Lower Thames Crossing

Planning Inspectorate Reference: TR010032

**PORT OF TILBURY LONDON LIMITED – RESPONSE TO DEADLINE 3 SUBMISSIONS
– ASDA ROUNDABOUT MODELLING**

Deadline 4: 19 September 2023

Figure 1 – Approximate length of mean maximum queue on the A126 Dock Road during Phase 1

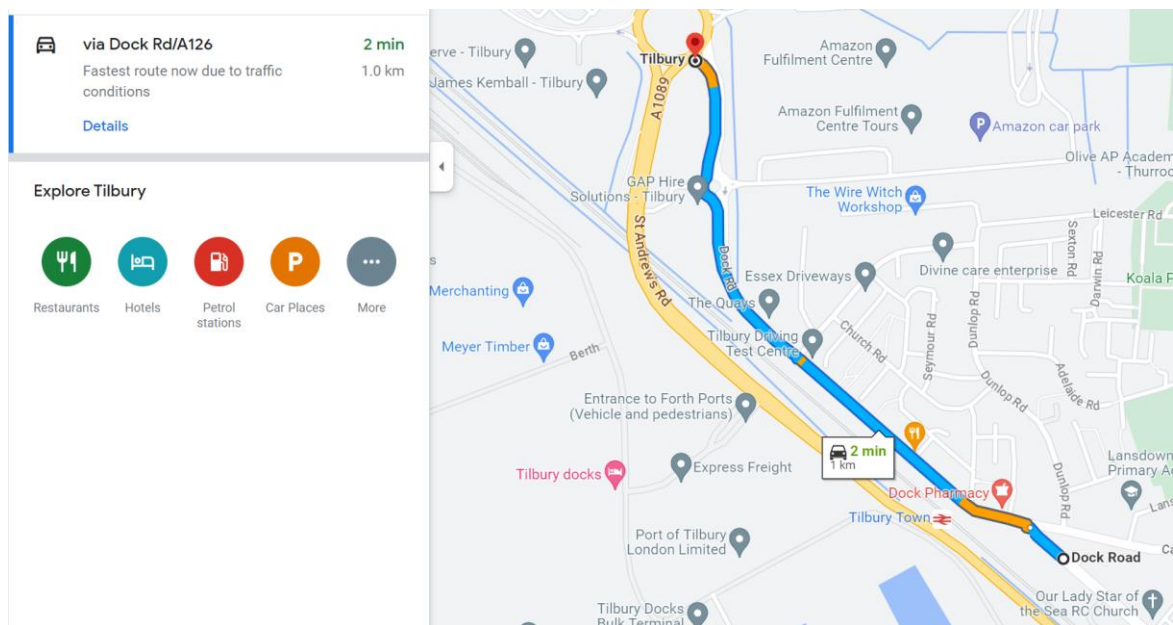
- 3.3 The mean maximum queue on the A126 Dock Road during Phase 1 is identified as over 1km in length – some 912m more than in the Do Minimum scenario. This queue would stretch past Tilbury Town railway station, passing two mini roundabouts connecting to further local roads in Tilbury. The impacts of this queueing have not been considered, despite the clear potential for there to be impacts on air quality, noise and vibration, and severance given the queue length outside the railway station.

TITLE: POTENTIAL LAND TO INCLUDE WITHIN ORDER LIMIT (RESPONSE TO EXA'S ACTION POINT ISH7-8)

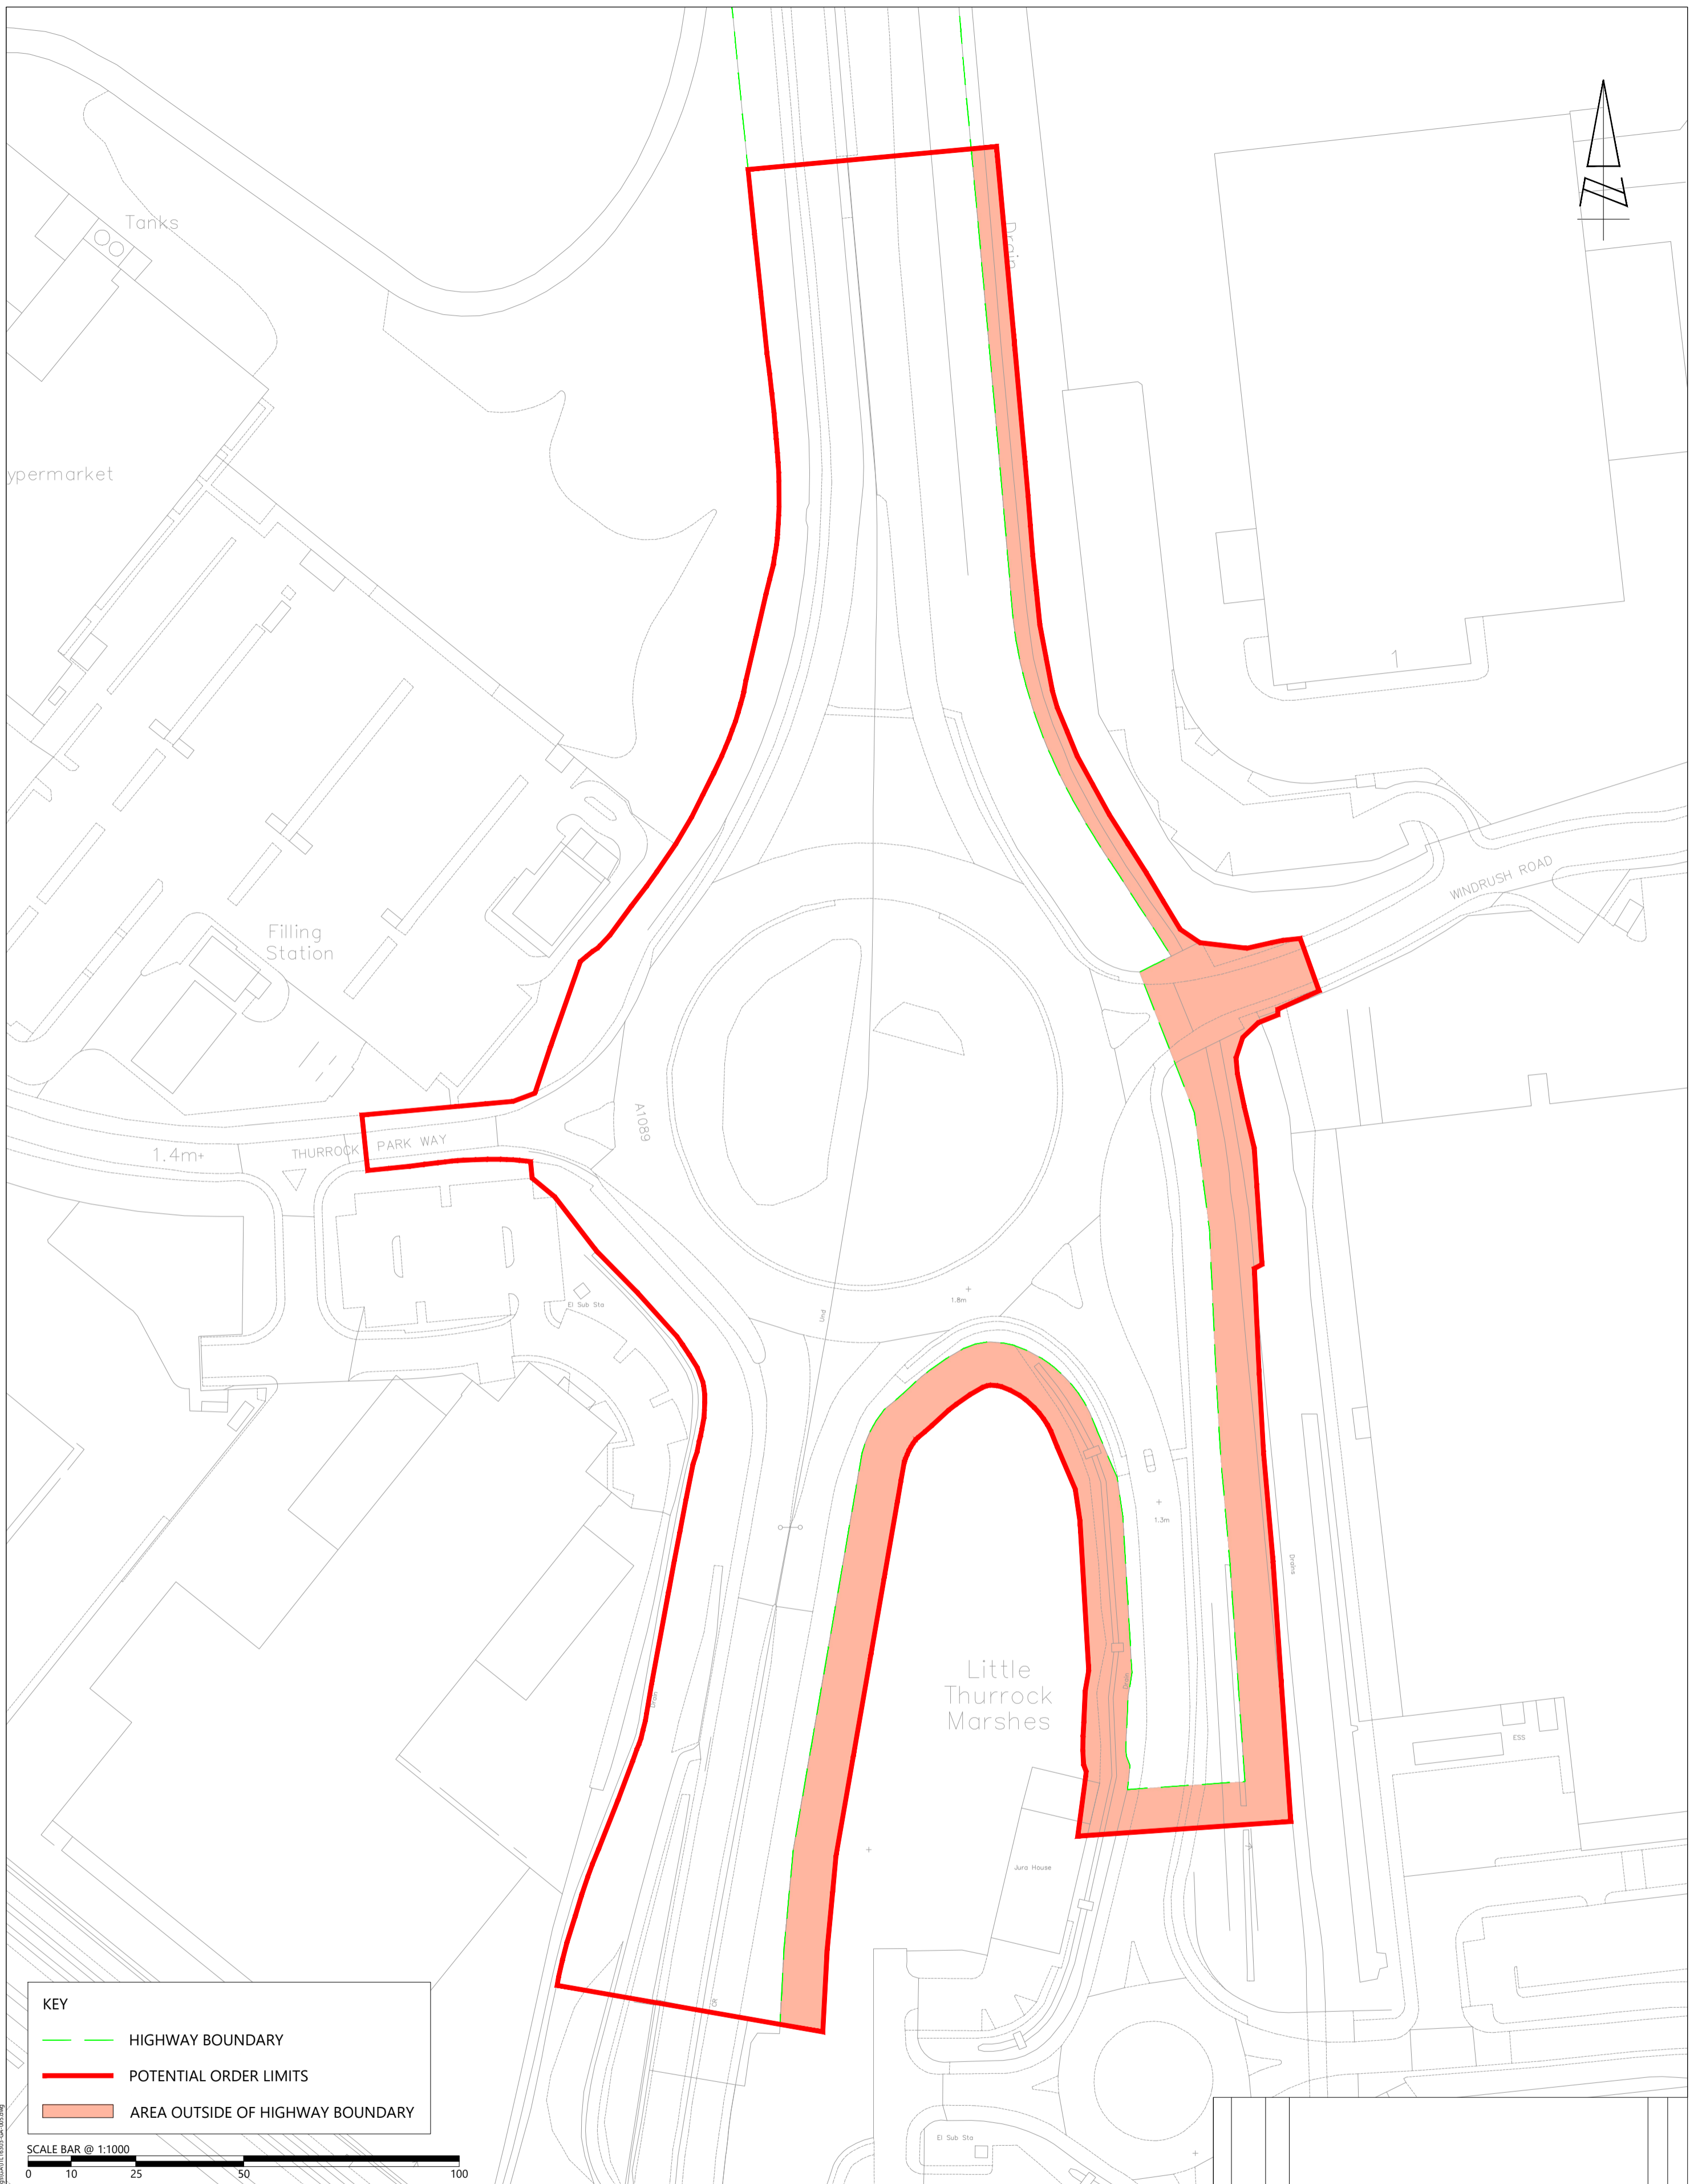
- 3.15 In response to the ExA's Action Point ISH7-8, PoTLL has provided a plan at Appendix 1 detailing the extent of the land that it considers should form part of the Order Limits in order to facilitate the Applicant providing such physical and other mitigation that may be required to avoid and minimise these impacts.

- 3.16 For the avoidance of doubt, this plan constitutes indicative requirements based on PoTLL's understanding of the expected impacts on the ASDA roundabout, as well as its own assessments of operation and the design of possible improvements. PoTLL hopes that this, combined with the Applicant's response to ISH7-8, will enable positive discussion to take place, and help the Applicant to identify urgently the design improvements and additional land required to be added to the Order in order to facilitate the required mitigation.

PoTLL has provided this plan in order to assist the ExA and the Applicant to understand the land take that would potentially be required in order to mitigate for the construction impacts of the LTC Scheme, as set out in 9.15 Localised Traffic Modelling Appendix M – ASDA roundabout VISSIM Construction Assessment Report [REP3-132].

It remains for the Applicant to assess the impacts of the LTC Scheme proposals properly, and to identify the design improvements to this junction, or elsewhere on the road network, to mitigate the identified impacts. The precise quantity of land and proposed Order limits will depend on the physical mitigation proposed by the Applicant. However, PoTLL hopes that this plan will assist all parties to understand that adding the ASDA roundabout to the Order limits is achievable within the Examination timetable, with only a limited number of affected landowners required to be consulted under the Compulsory Acquisition Regulations.
